Access Compliance Report

Public Rights-of-Way

(Curb Ramps)

Intersection ID: 3980	Main Street: GANNETT_DR	Cross Street: STONY_PATH_DR	Location: S
ADA ID: 581AD5A6A168	Ramp Type: Perp	Initial Pass/Fail: Fail	Overall Compliance: No
Severity Score: 22.5			
Codes/Mitigation Info/Possible Solution		Field Measurements/Component Compliance

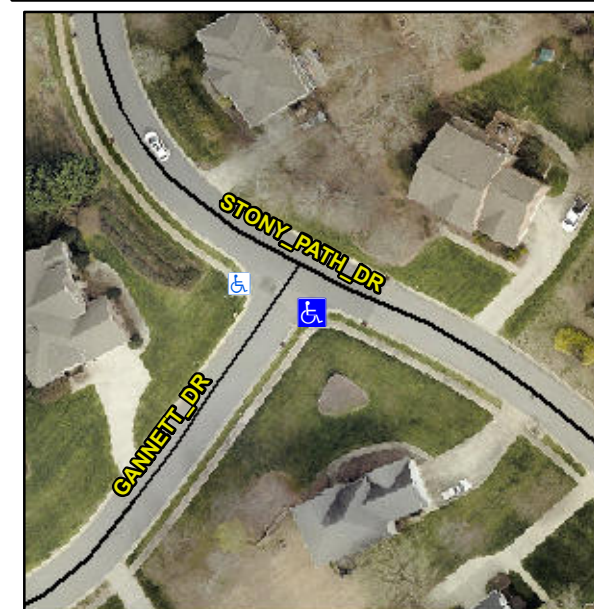
Not Found, R304.5.1, R304.2.2, R304.5.3

Compliance	Description	Data	Compliance	Description	Data
N/A	Ramp Length (in)	49.5	No	Ramp Slope (%)	9.6
No	Ramp Width (in)	40.0	No	Ramp XSlope (%)	4.6
N/A	Flare Type LT	N/A	N/A	Flare Type RT	N/A
N/A	Flare Slope LT (%)	N/A	N/A	Flare Slope RT (%)	N/A
N/A	Flare Traversable LT?	N/A	N/A	Flare Traversable RT?	N/A
N/A	Landing Length (in)	N/A	N/A	DWS Provided?	N/A
N/A	Landing Width (in)	N/A	N/A	DWS Contrast?	N/A
N/A	Landing Slope (%)	N/A	N/A	DWS Length (in)	N/A
N/A	Landing X Slope (%)	N/A	N/A	DWS Full Width?	N/A
N/A	Landing Curb? (Y/N)	N/A	N/A	DWS Offset (in)	N/A
N/A	Shared Landing?	N/A			
N/A	Gutter Ponding?	N/A	N/A	Gutter Slope (%)	N/A
N/A	Gutter Lip Ht (in)	N/A	N/A	Gutter X Slope (%)	N/A
N/A	Painted X Walk1?	No	N/A	Painted X Walk2?	N/A
	X Walk 1 Direction	To NW		X Walk 2 Direction	N/A
N/A	X Walk 1 Width (in)	N/A	N/A	X Walk 2 Width (in)	N/A
	X Walk 1 Slope (%)	7.1		X Walk 2 Slope (%)	N/A
	X Walk 1 X Slope (%)	0.9		X Walk 2 X Slope (%)	N/A

Remove & Replace Entire Ramp.
